DESIGN ADVISORY BOARD Tuesday November 23, 2021 3:00 PM

DESIGN ADVISORY BOARD

To: The Design Advisory Board
From: Mary O'Neil, AICP, Principal Planner
RE: ZP21-509 72-76 Elmwood Avenue
Date: November 23, 2021

To: The Design Advisory Board
From: Mary O'Neil, AICP, Principal Planner
RE: 111 North Winooski Avenue ZP21-606
Date: November 23, 2021

SCALE: 3/16" = 1'-0

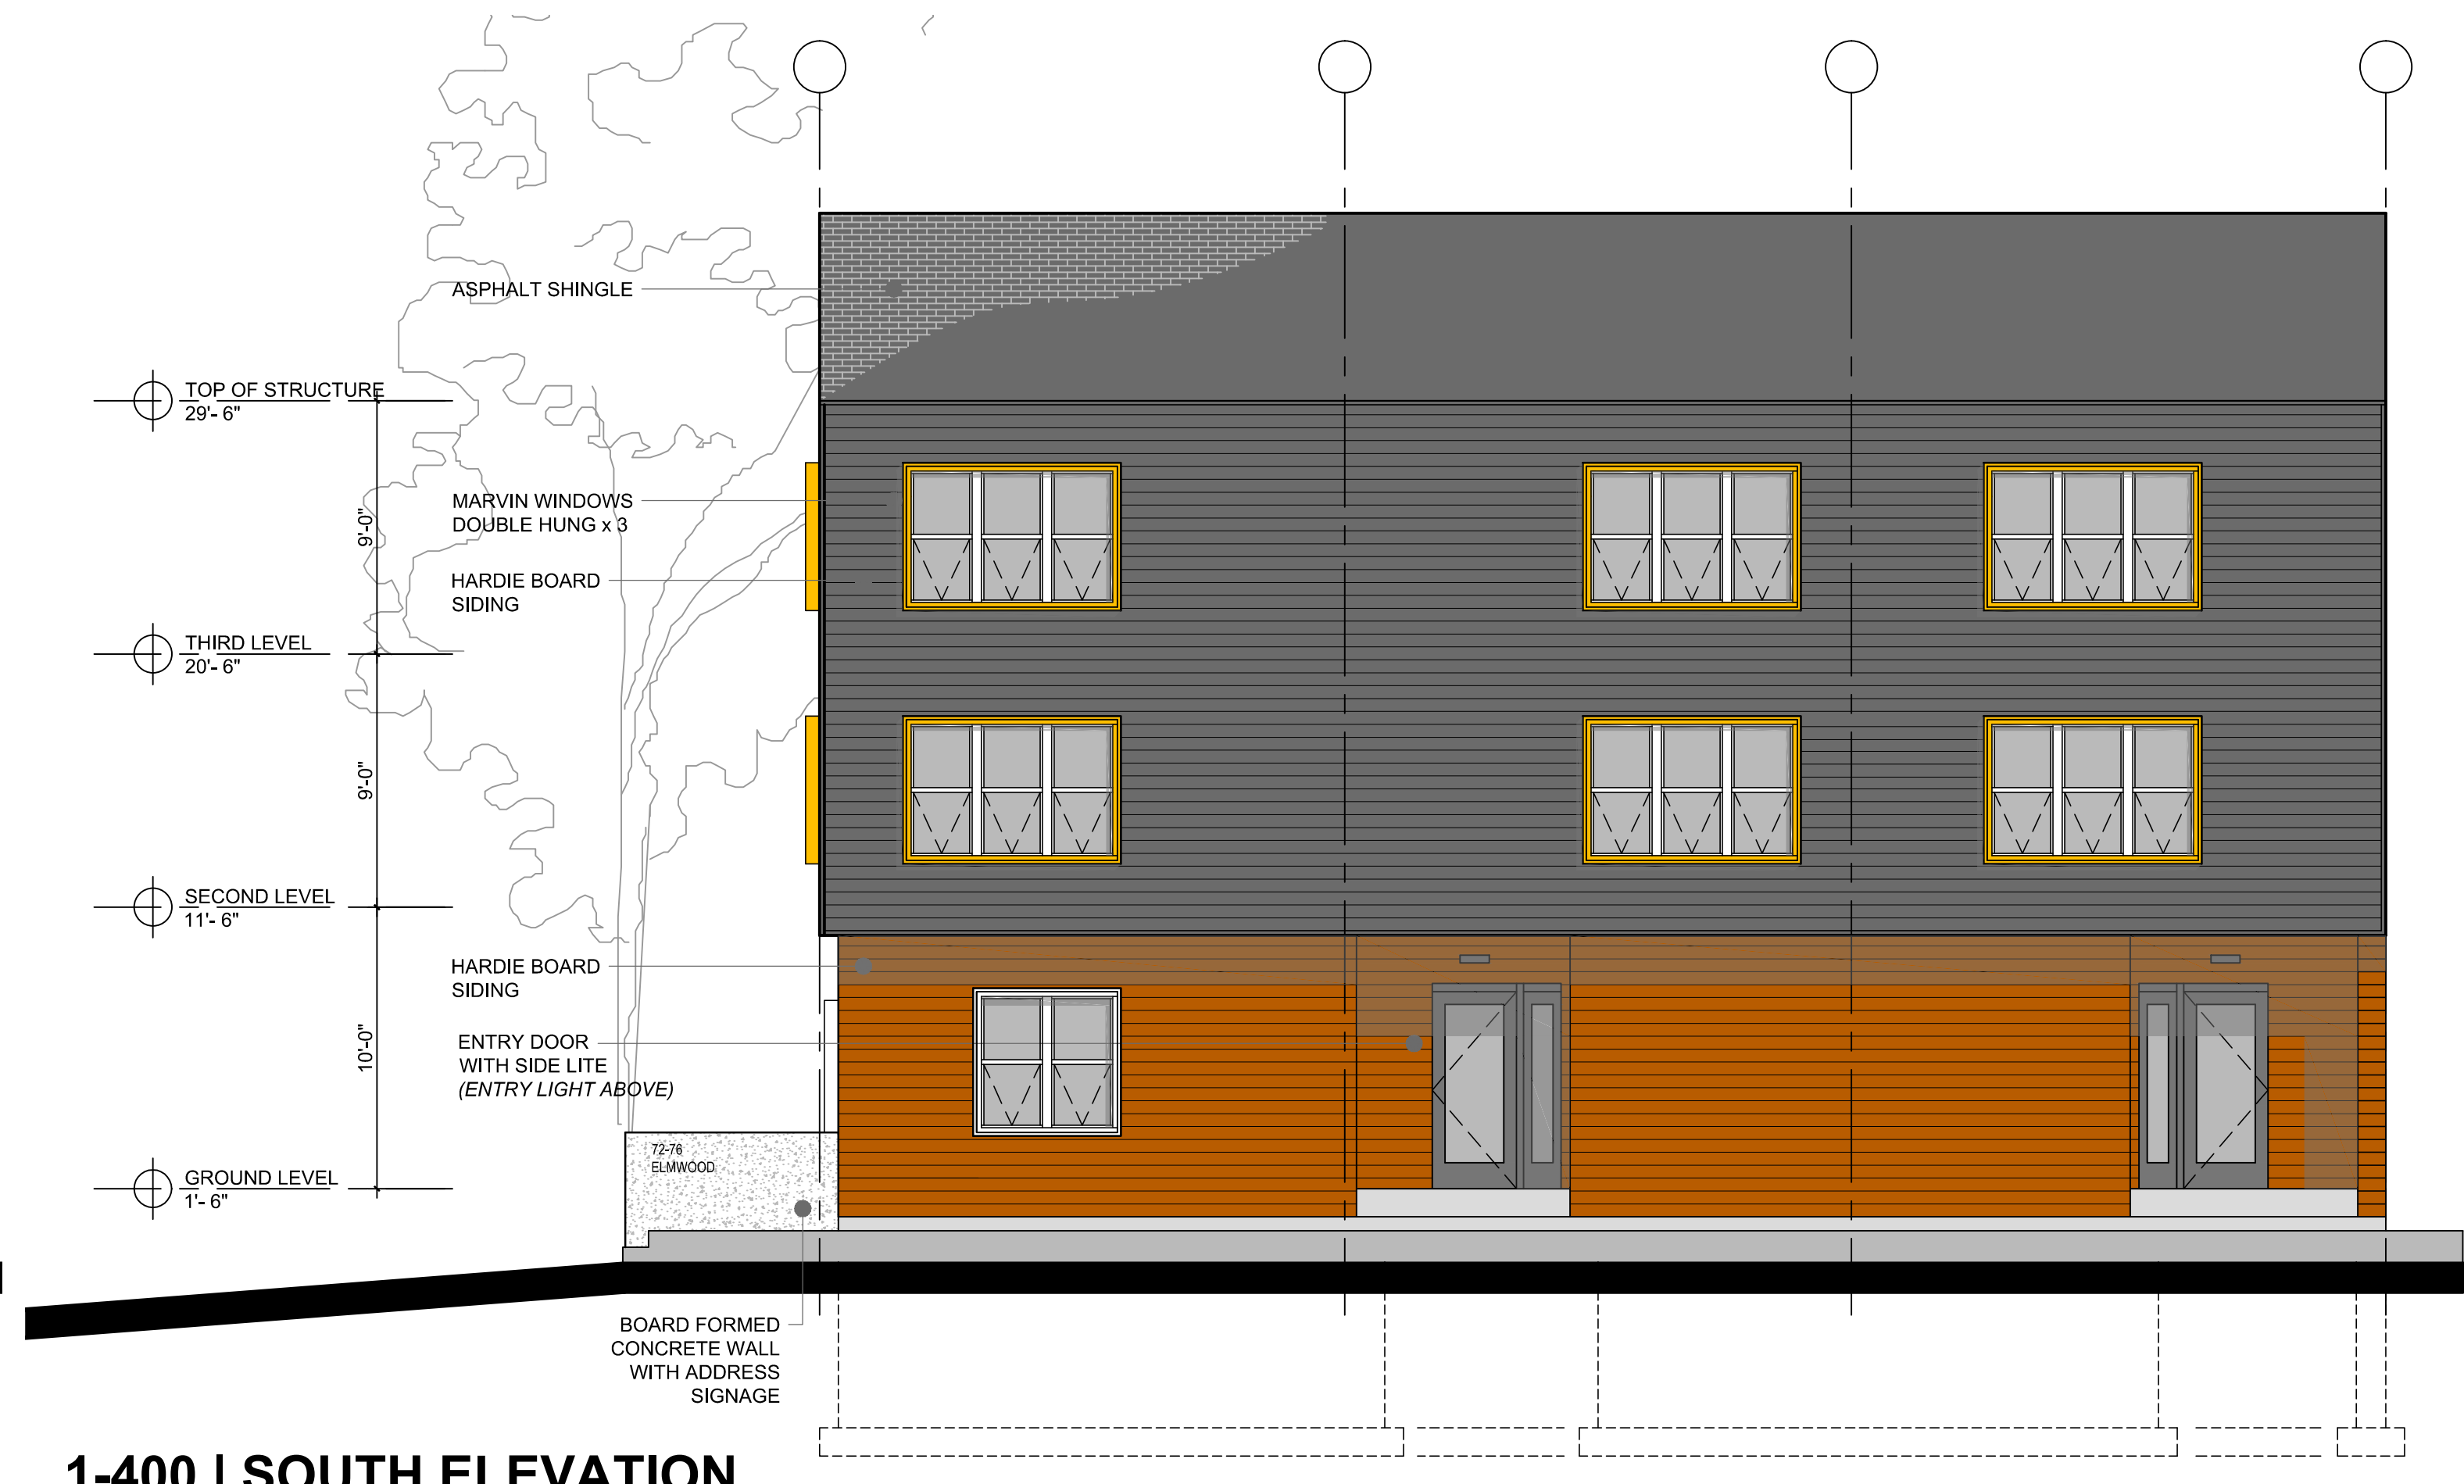
The proposed building has a modified cat-slide roof with dual pitch and zero eave extrusion. Responding to DAB comments, snow guards and rain gutters have been added on the north and south elevations. In style it reads as a modern infill.

As designed, the building lacks typical façade articulation such as bays, horizontal and vertical façade articulation, porches, patios, articulated bases, step-backs or other street level details. Windows are stacked, however, providing a measure of arrangement. The plan is modernistic with a simplified form and little detailing. The only interest provided is the angular and asymmetrical roof line, and “framed” window surrounds. Revisions include a differentiated first floor south and west entry, as requested by the Design Advisory Board.

North side of carriage barn. Photo taken from abutting property, parking area.

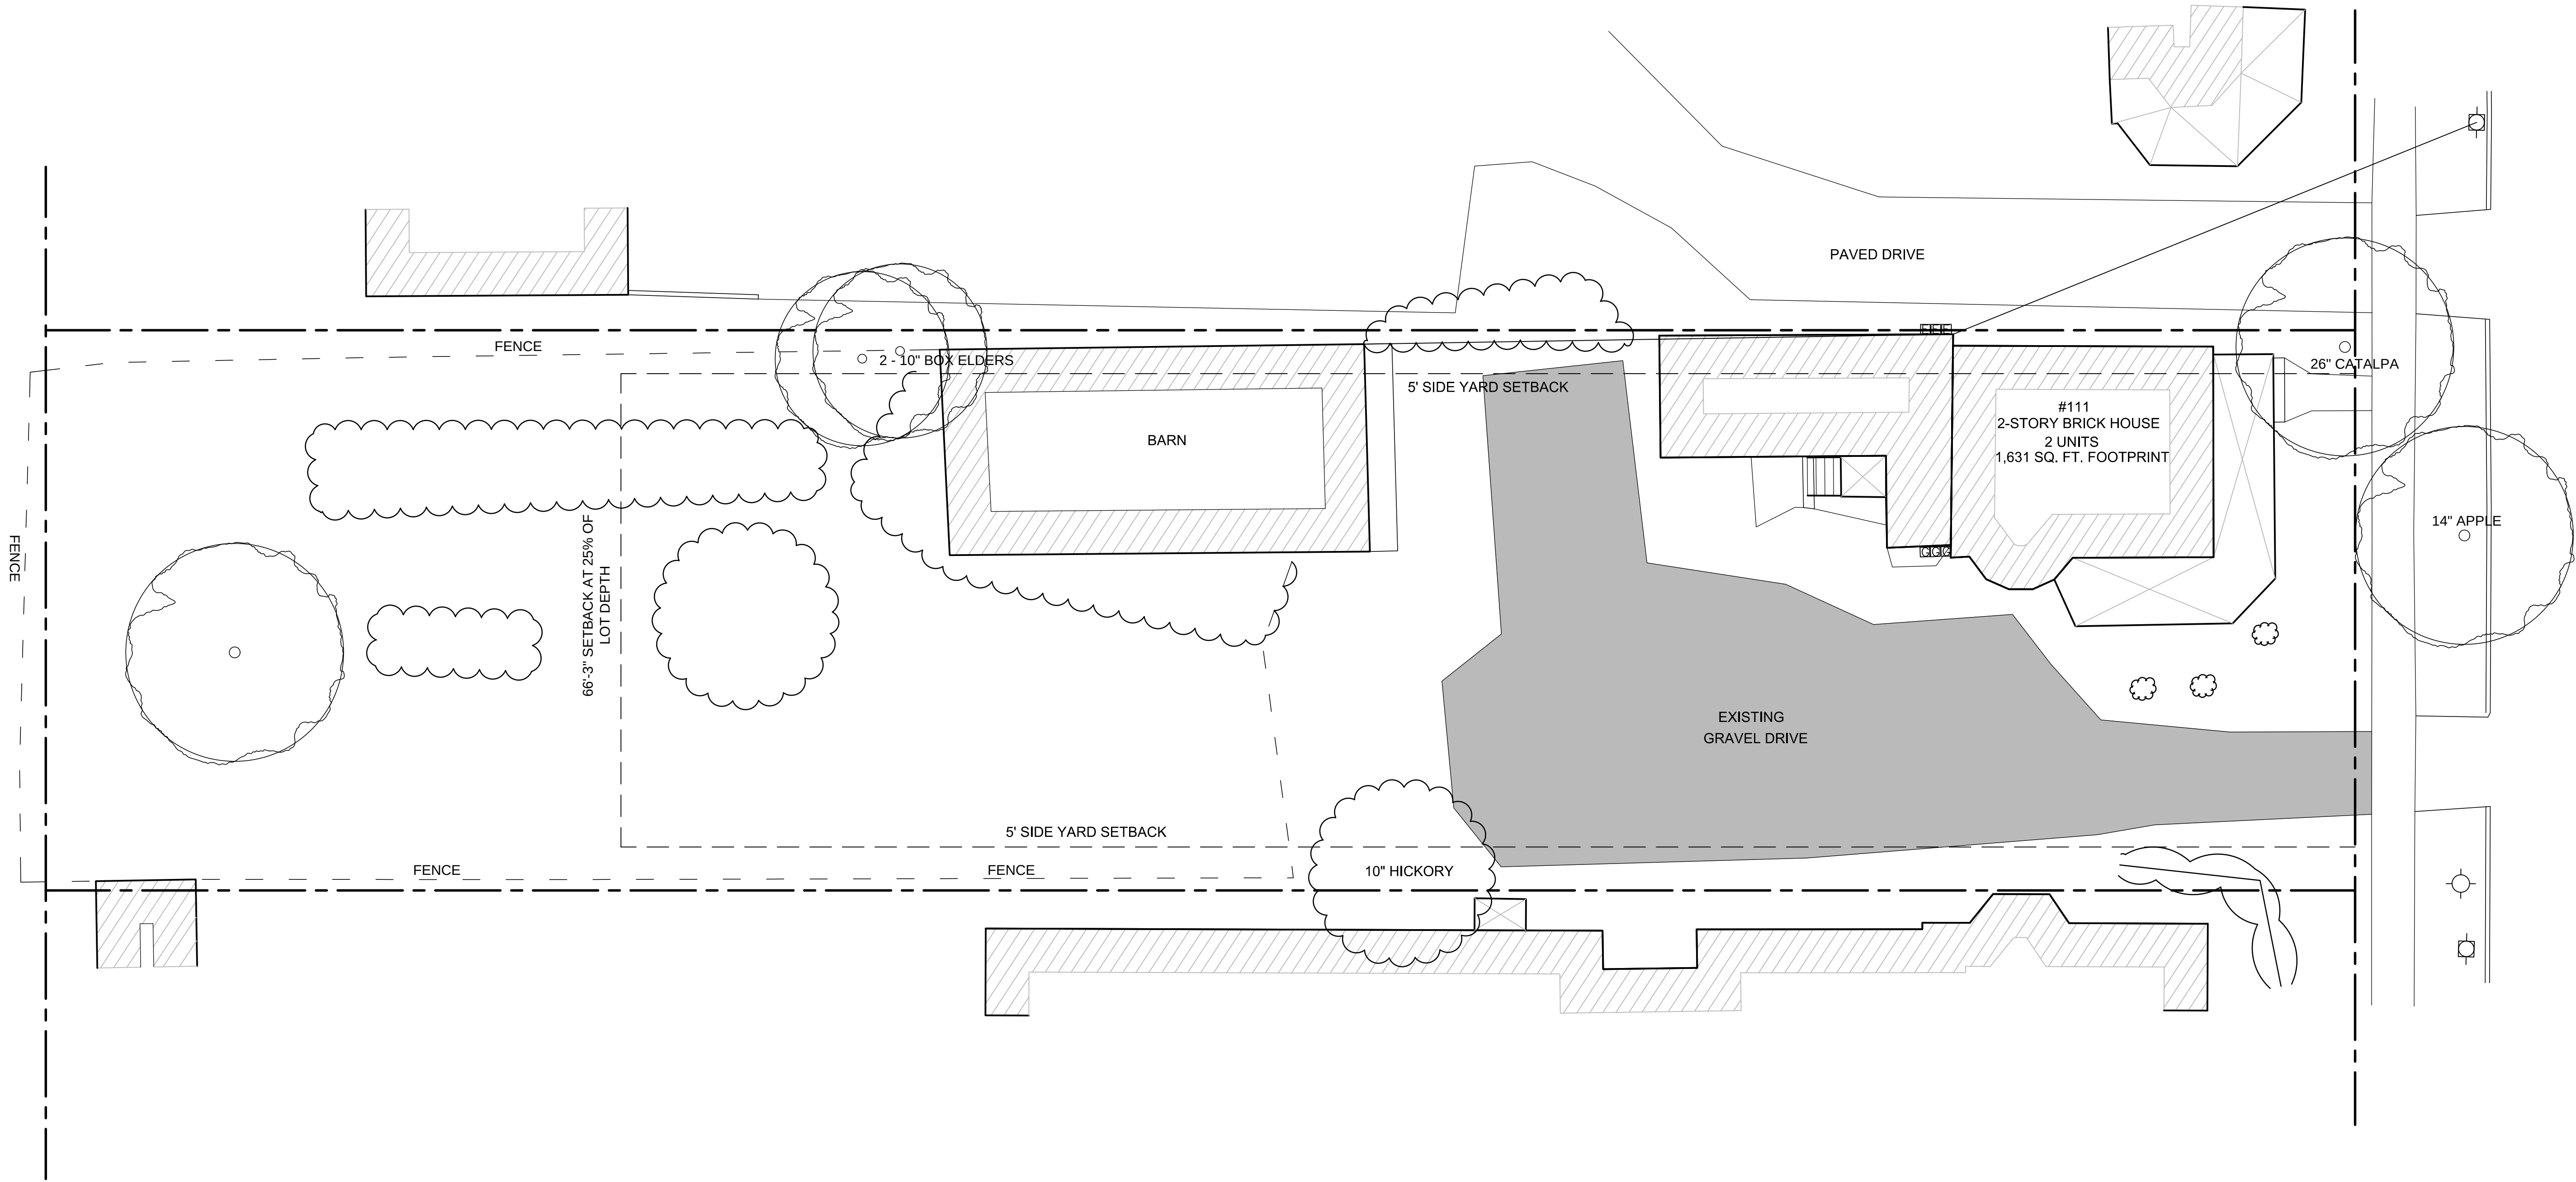
The unlikely removal of the new detached structure will render the principal structure intact and easily discernable as historic. There is little chance the carriage barn, however, can be resurrected to complete the historic building context.

**EXISTING
CONDITIONS**

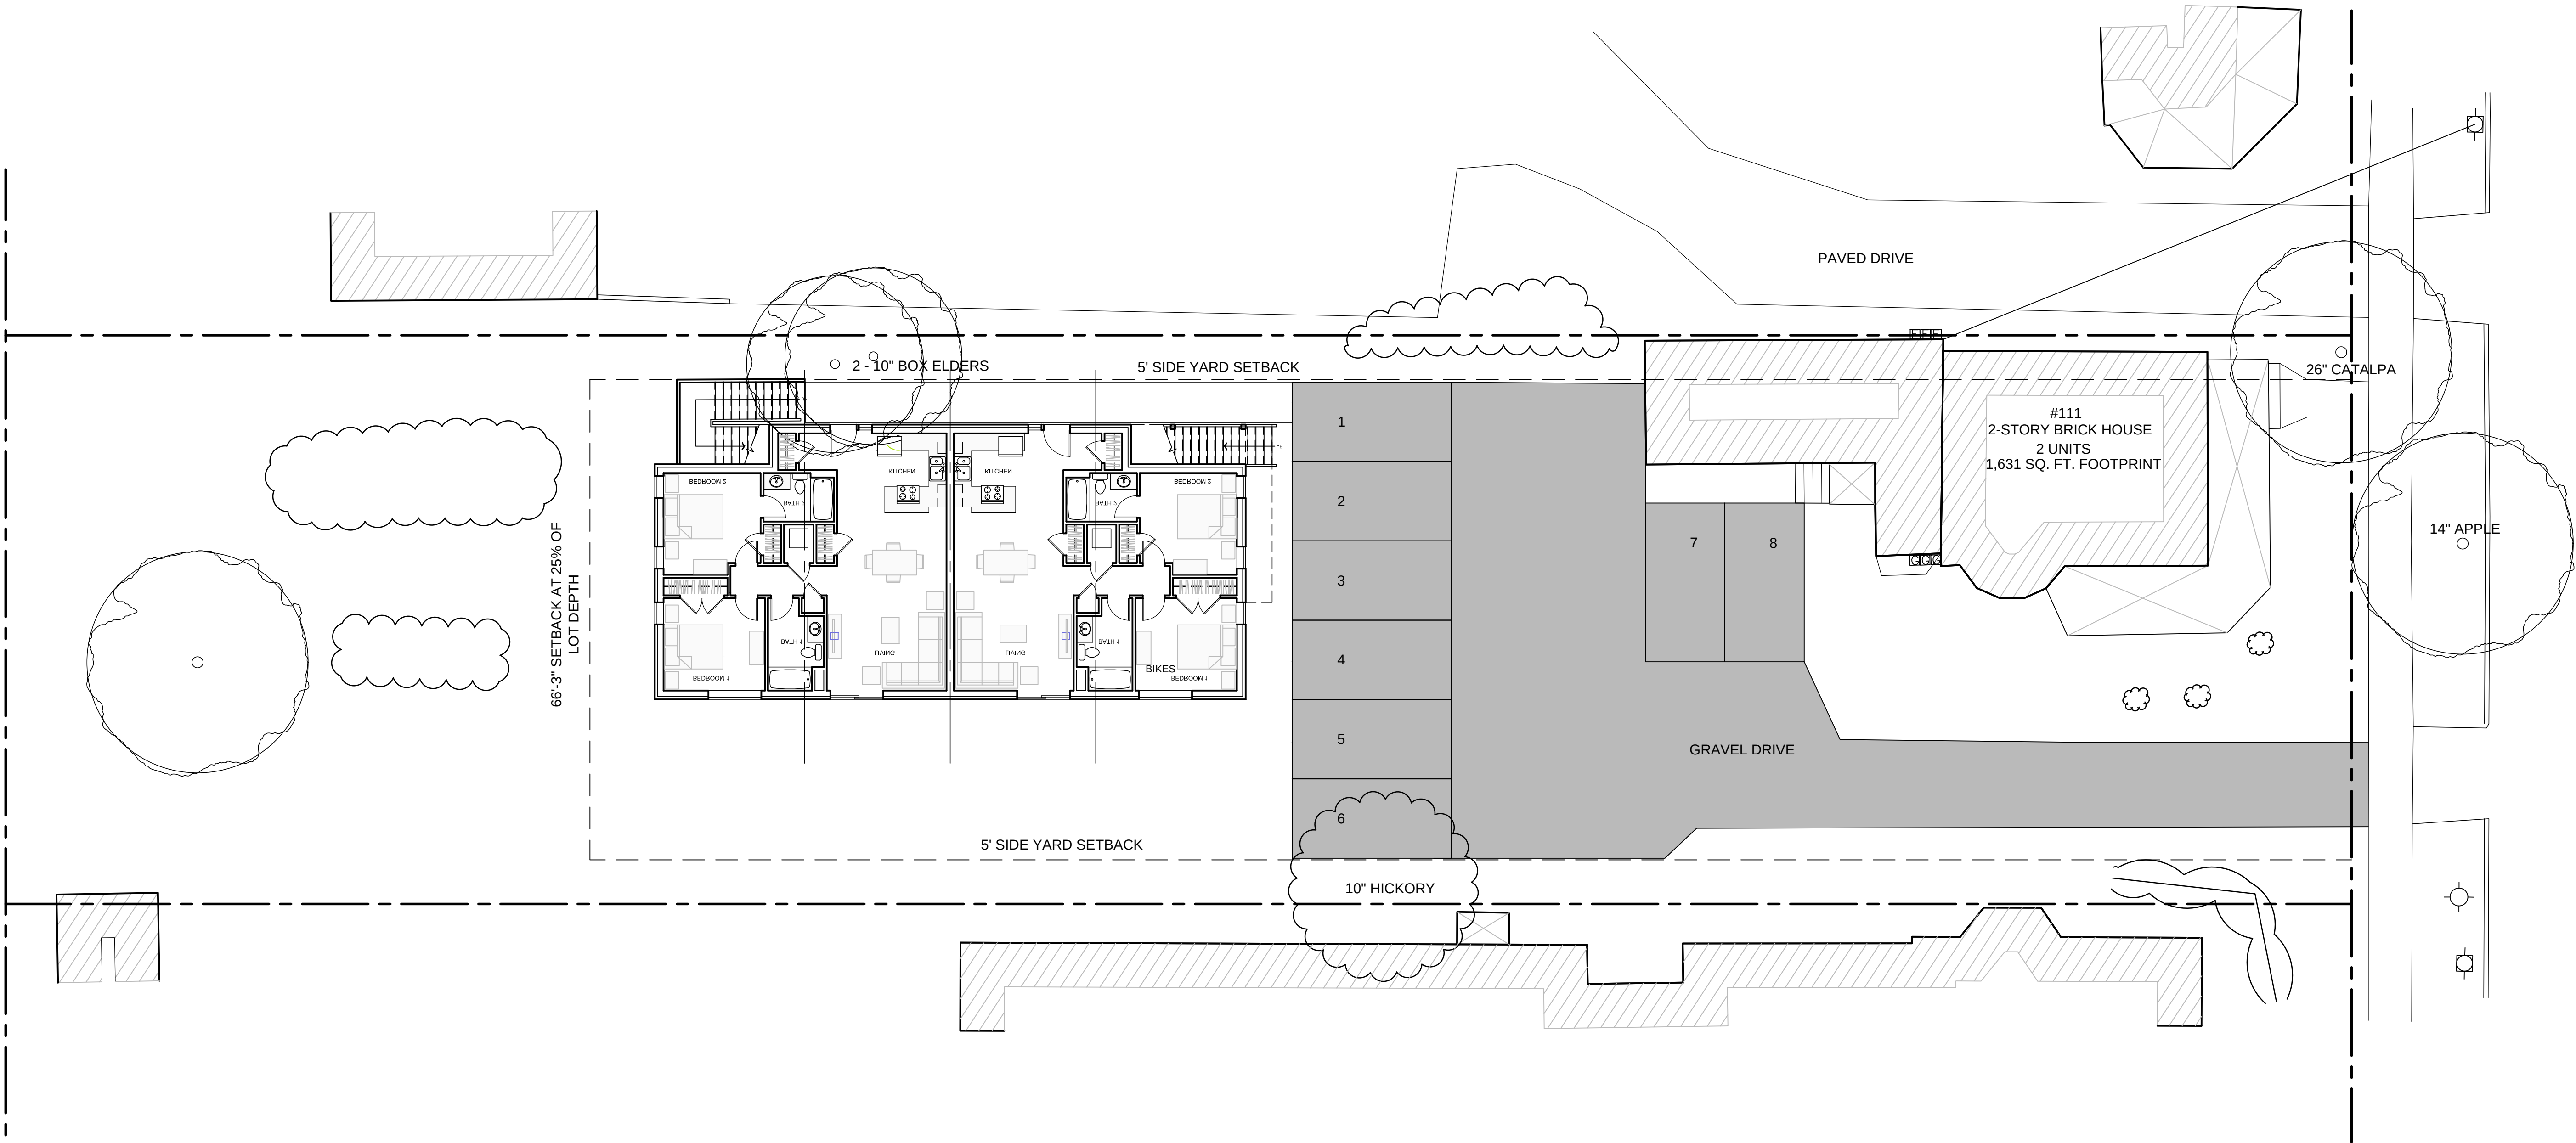
The proposed site plan identified 2 box elders on the north property line intended for retention. At least one other mature tree is proposed to be removed. The applicant shall further define the landscaping plan, particularly on tree removal and

As noted, a landscaping plan articulating any tree cutting or new plantings shall be provided. The applicant shall also relocate the fence within the identified property boundaries.

The plan does not identify any trash or recycling facilities, meters, mailboxes, utility connections or HVAC equipment. All shall be illustrated on elevations and/or site plans as appropriate. Screening may be appropriate.

1. A landscaping plan, with tree removal and new plantings identified is required.

2. Review by the Stormwater program is required, with completion of an Erosion Prevention and Sediment Control Plan.
3. An identified pedestrian walkway shall be introduced between the parking area and the public sidewalk.
4. The fence shall be relocated onto the subject property, as the survey has indicated it is placed outside the parcel in some instances.
5. The addition of 5 or more units spurs the requirement for Inclusionary zoning. At least one new unit must be affordable. The applicant is encouraged to consult with the Housing Trust Fund manager to define rental levels and associated details.
